## **HISTORIC LANDMARKS COMMISSION**

**July 14, 2022**

Subject: **Request for Certificate of Appropriateness HLC2021-00018**, submitted by Gayon Burford-Williams, property owner, for exterior modifications at 133 Clay Street. The property is further identified as Tax Map 34G18(A)\*349, Suffolk Voting Borough, zoned CBD, Central Business District zoning district, and HC, Historic Conservation Overlay District.

## STAFF REPORT

# Proposed Paint Color for Perimeter Brick

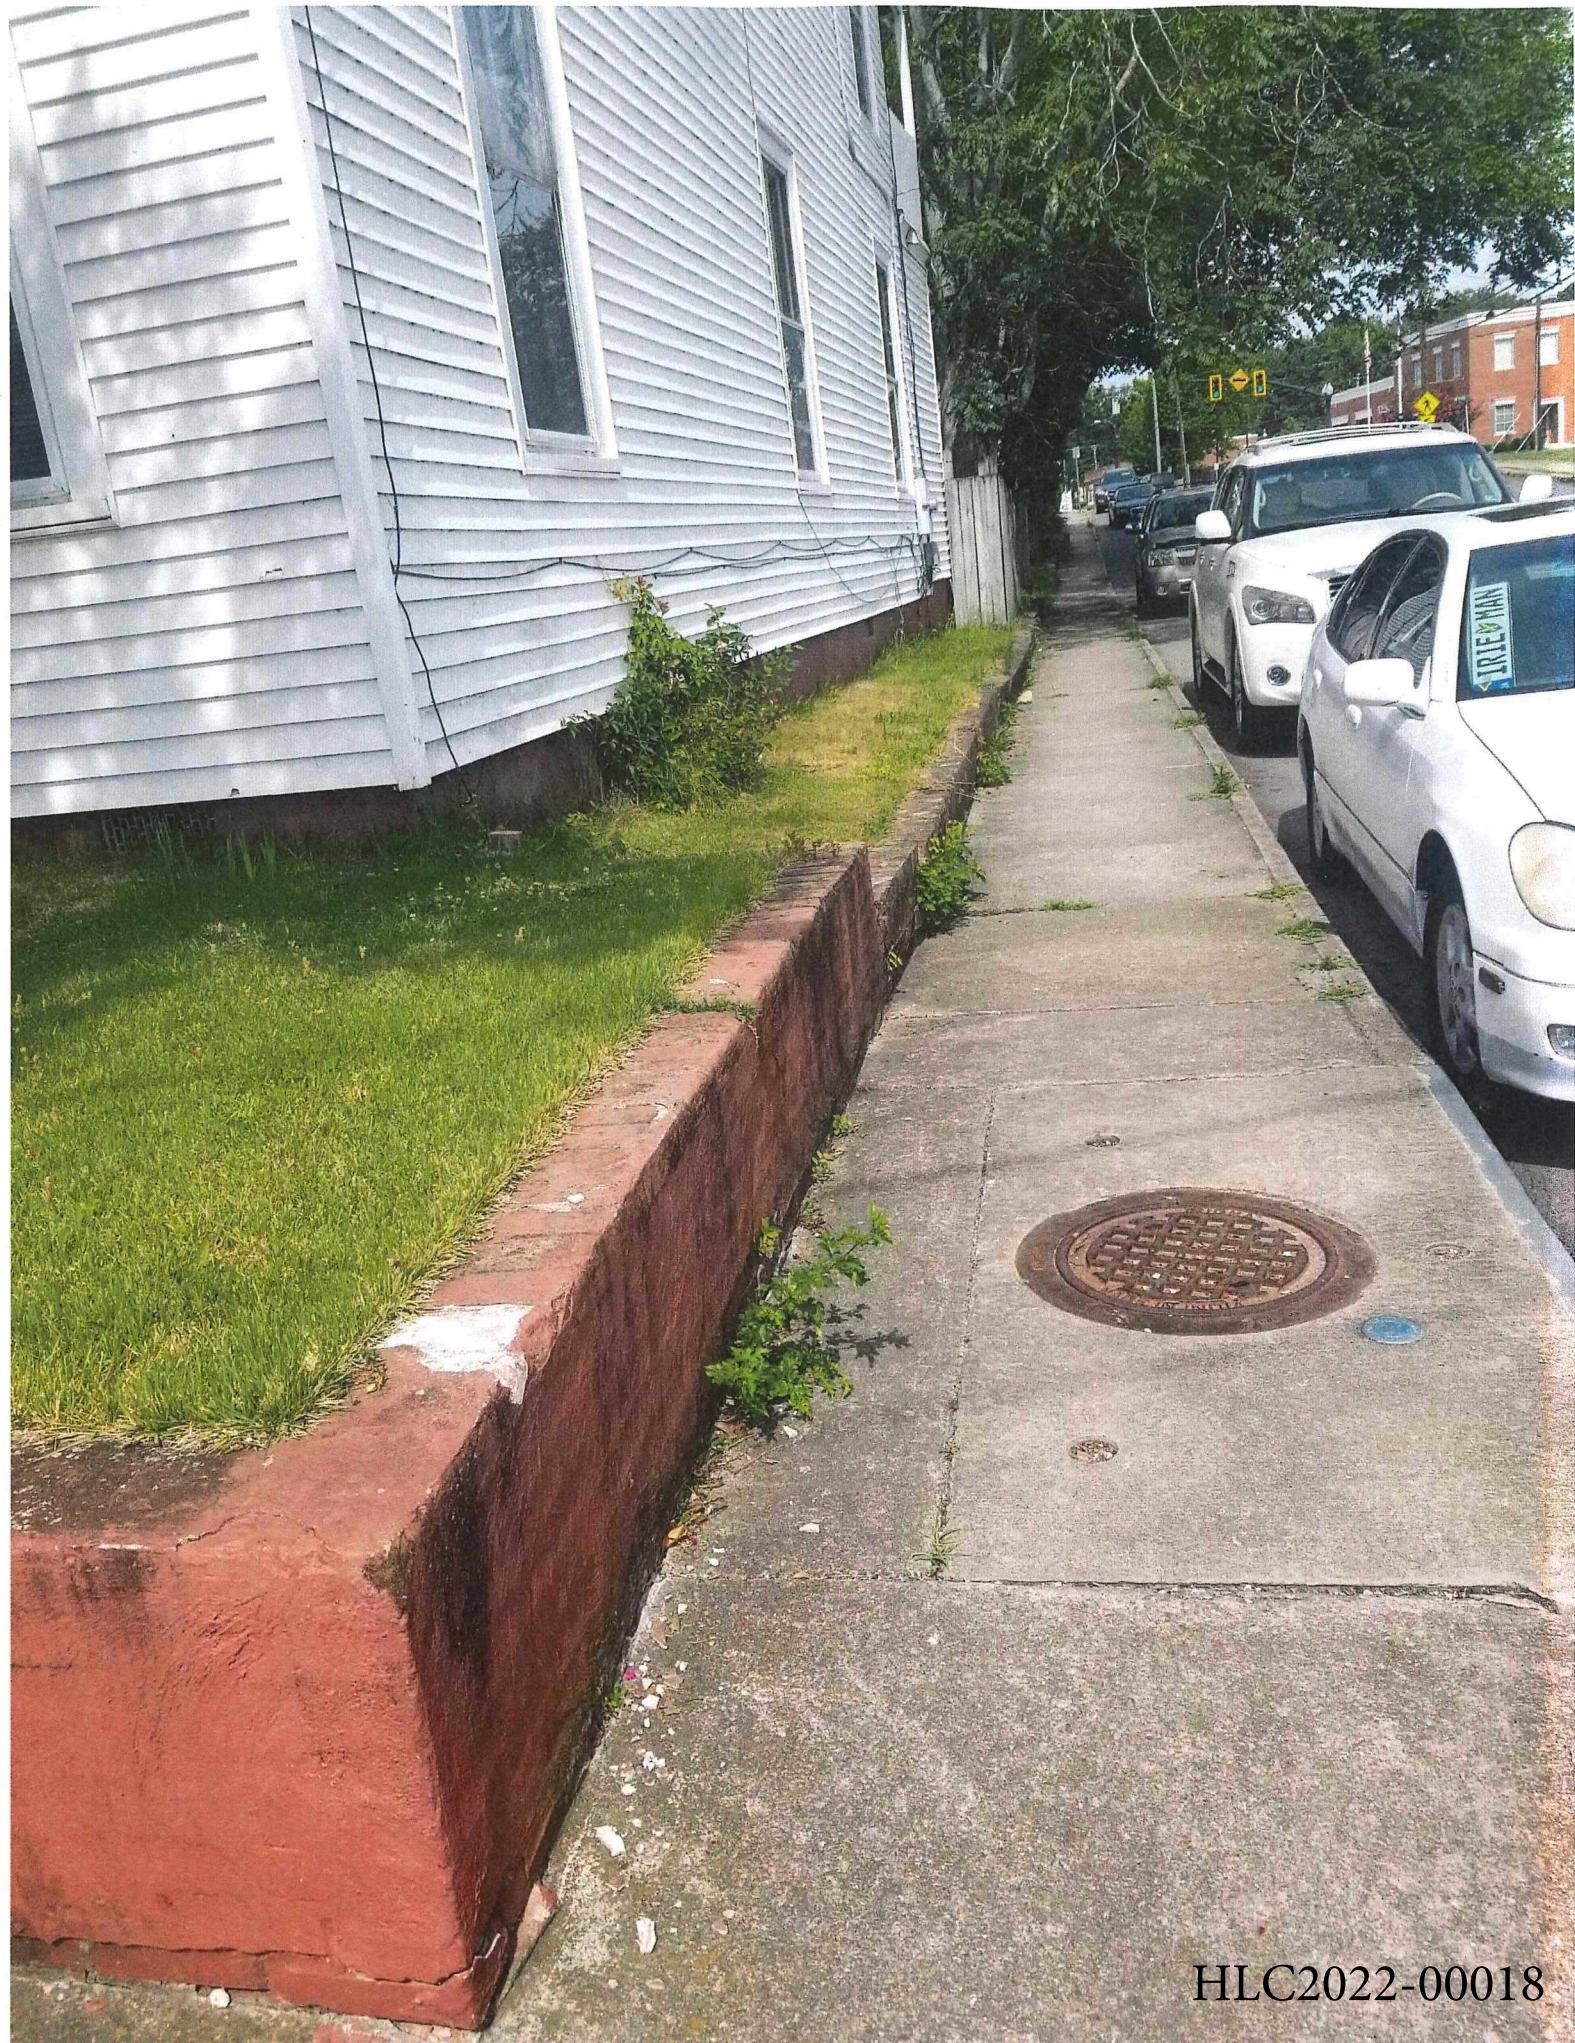
Finally, when evaluating the Guidelines, the painting of unpainted brick in an opaque color is not permitted however, as the brick is already painted and chipping the applicant would like to repaint in the color Behr's Artic Gray Elastomeric Masonry, Stucco and Brick Exterior paint or a similar color. Therefore, staff finds that this application as presented generally conforms to the Historic District Design Guidelines.

1. Installation of one 17.5" x 35.5" Anderson Essential Style Elements, American Farmhouse Quintessential, two-over-two double-hung window in the primary bedrooms on suite bathroom in the location shown in the attached picture.
2. Repaint the perimeter brick in the color Behr's Artic Gray Elastomeric Masonry, Stucco and Brick Exterior paint or a similar color.
3. Any additional improvements shall require a Certificate of Appropriateness.
4. All required permits shall be obtained from the City of Suffolk.

## Proposed window placement

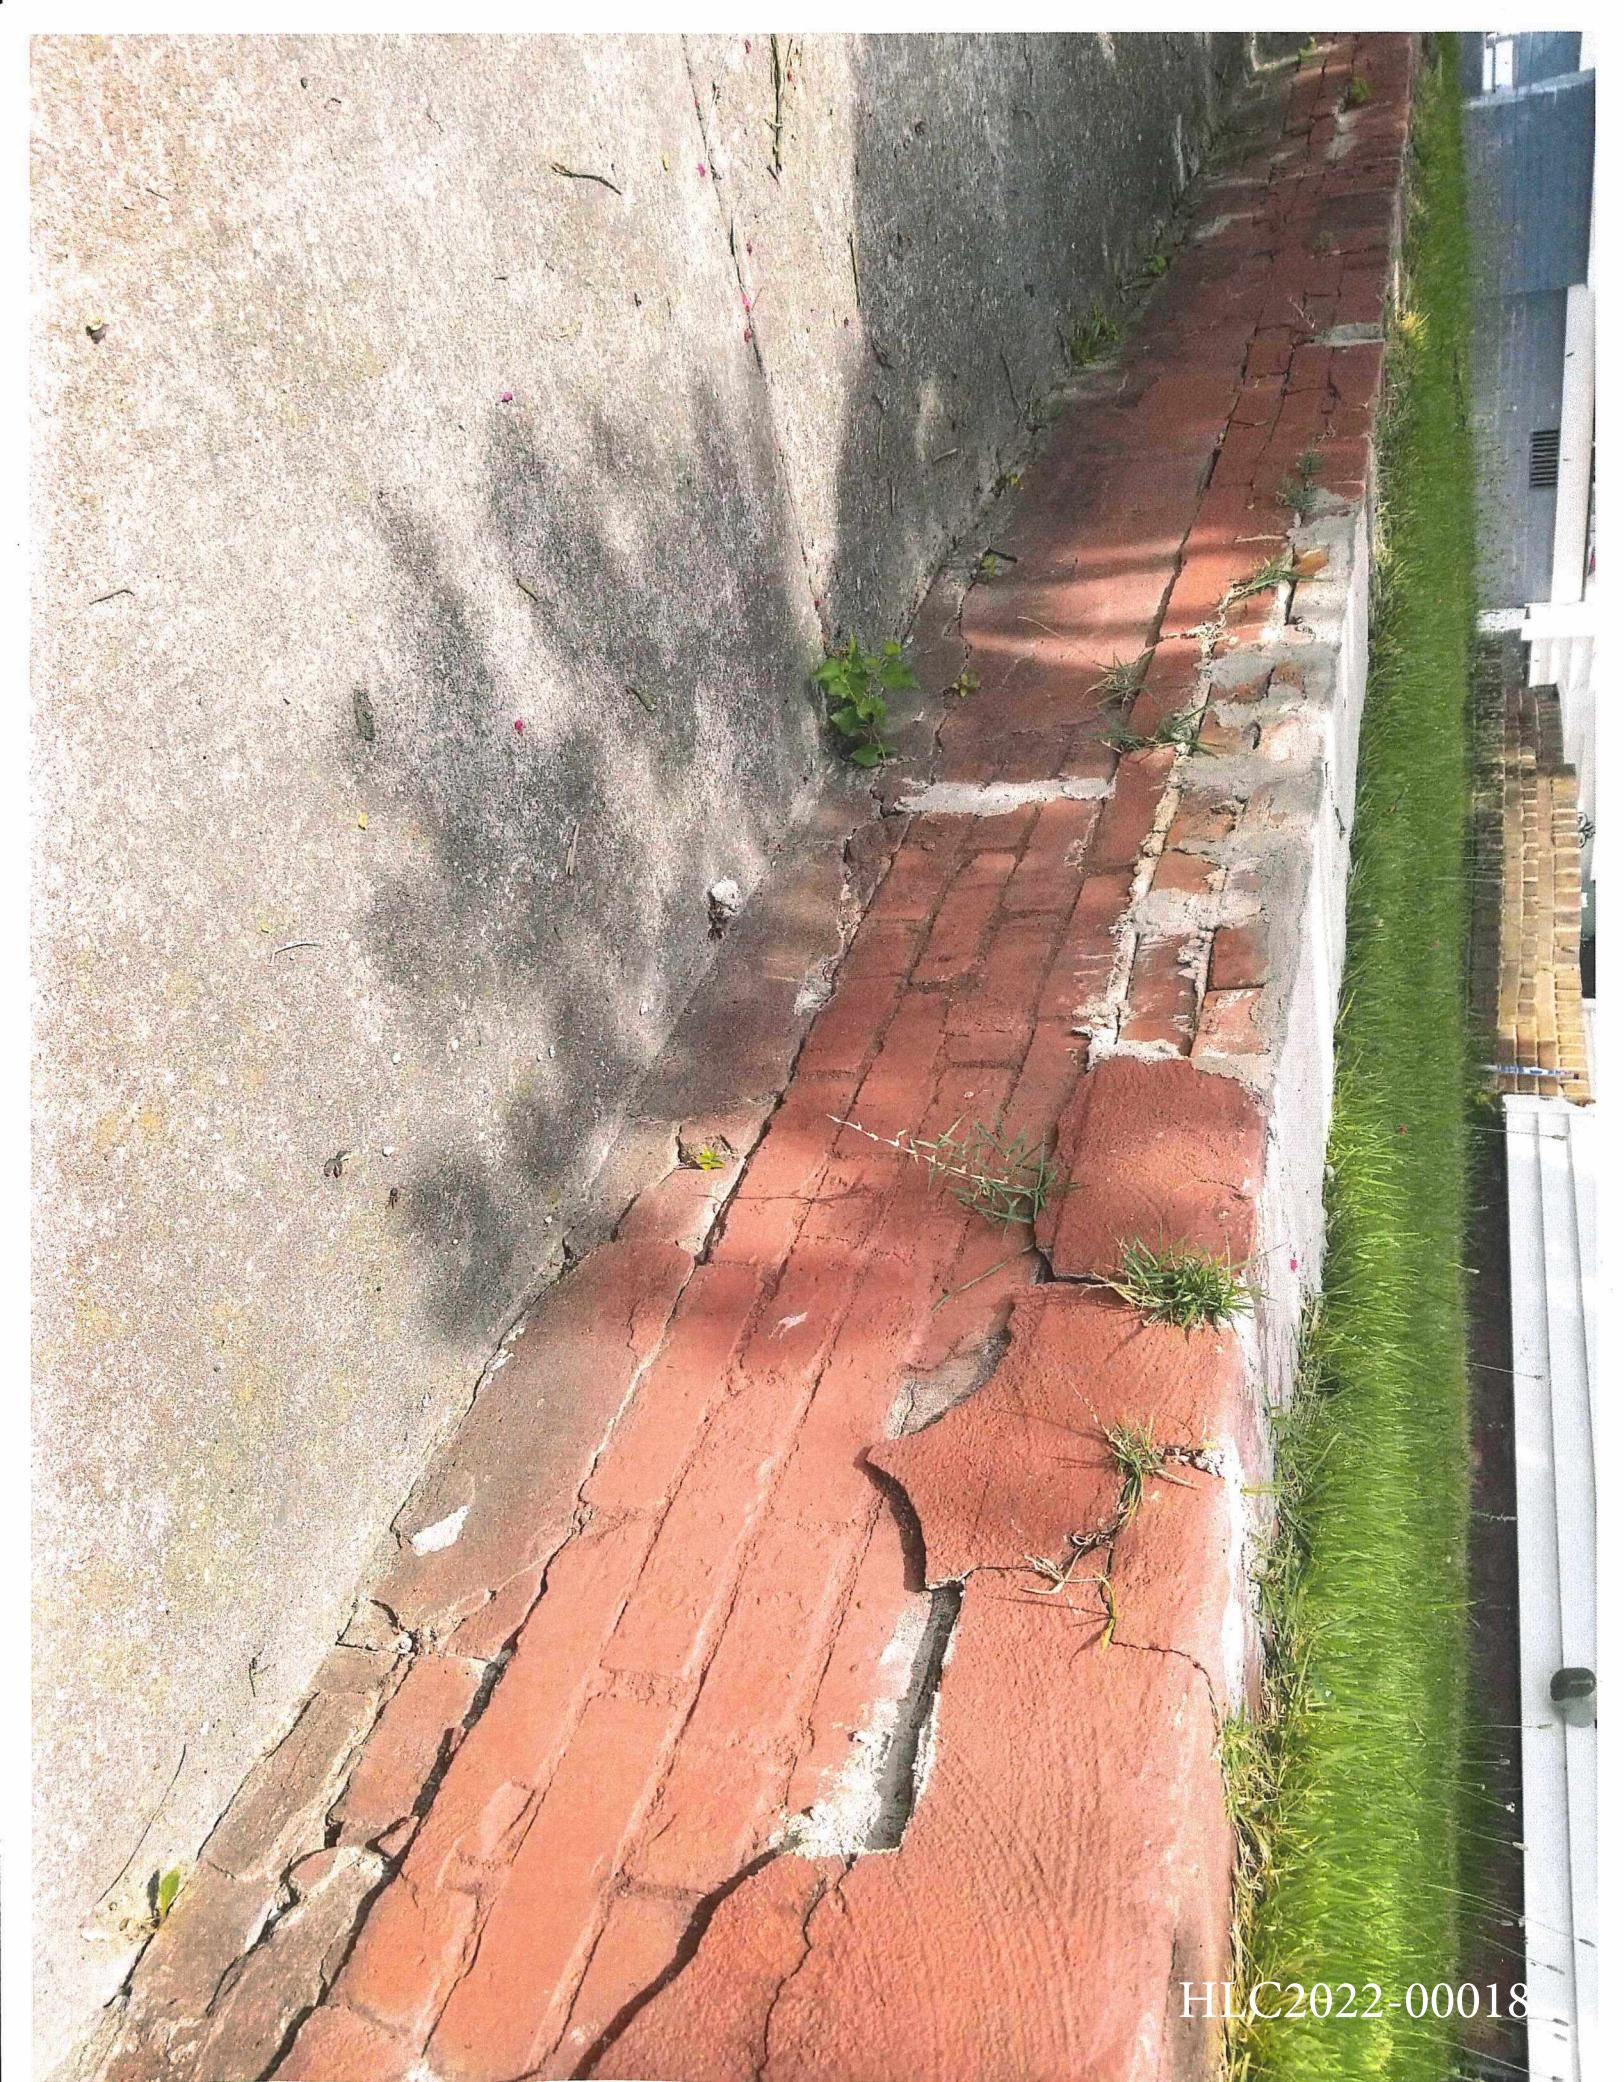
As stated above, the applicant is requesting to install one 17.5" x 35.5" Anderson Essential Style Elements, American Farmhouse Quintessential, two-over-two double-hung window in the primary bedroom's on-suite bathroom as they have stated there is a buildup of moisture, mold, and mildew that the installation of this window would alleviate. Staff evaluated this application according to the Design Guidelines and Secretary of Interior's Standards. For the windows, within the Historic District, painted wood, metal clad or vinyl clad are generally allowed, as outlined in Section C.3 of the Design Guidelines. However, Staff also evaluated the windows according to further guidance in this section, related to kind and texture of materials, architectural and historical compatibility, comparison to original window profile, level of significance of original windows to the architectural style of the building, and material performance and durability. While Staff reviewed the proposed window for installation, an Anderson Essential Style Elements, American

Farmhouse Quintessential, two-over-two double-hung window, and have found it to be consistent when considering the pattern of the other windows on the second story right façade of the structure. The original windows are two-over-two windows and do not have an ornate patterns or a unique usage of glass. The addition of the two-over-two window will not significantly affect the character or style of the structure.
